ENGINEERING EVALUATION OF THE WNP-2
SACRIFICIAL SHIELD WALL

SUPPLEMENT NO. 1

Washington Public Power Supply System
WPPSS Nuclear Project No. 2
Sacrificial Shield Wall - Evaluation Program
Proposed Correction at Interface El. 541'-5"
Technical Memorandum No. 1196

SUBJECT W. O. 2808
Washington Public Power Supply System
WPPSS Nuclear Project No. 2
Sacrificial Shield Wall
NRC Concern: Use of Lead in Shielding Material
Technical Memorandum No. 1197

J. COMPARISON OF PROPOSED CORRECTION WITH ORIGINAL SLOT WELDS

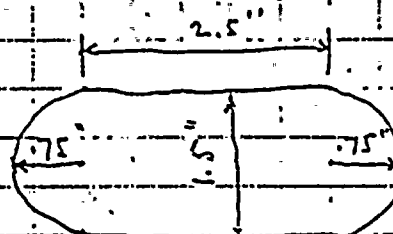
- o Clarify the original intent of the dimensional tolerances associated with the fabrication of the SSW.
- o Provide the as-built dimensional information associated with the out-of-roundness and verticality of the SSW adjacent to the 541'-5" elevation.
- o Provide the design margin of the original plug weld design.
- o Provide an assessment of the secondary stresses of the proposed partial penetration weld due to its eccentricity.
- o Discuss the leachability of lead from the selected shield material and provide the results of the various qualification tests.
- o Provide the rationale for leaving known defects in the SSW.

THIS DESIGN MARGIN IS LESS THAN D.M. = 2.39 WITH CORRECTION WELD FOR SAME DESIGN LOADING.

PROPOSED CORRECTION WELD PROVIDES GREATER CAPACITY THAN ORIGINAL SLOT WELDS.
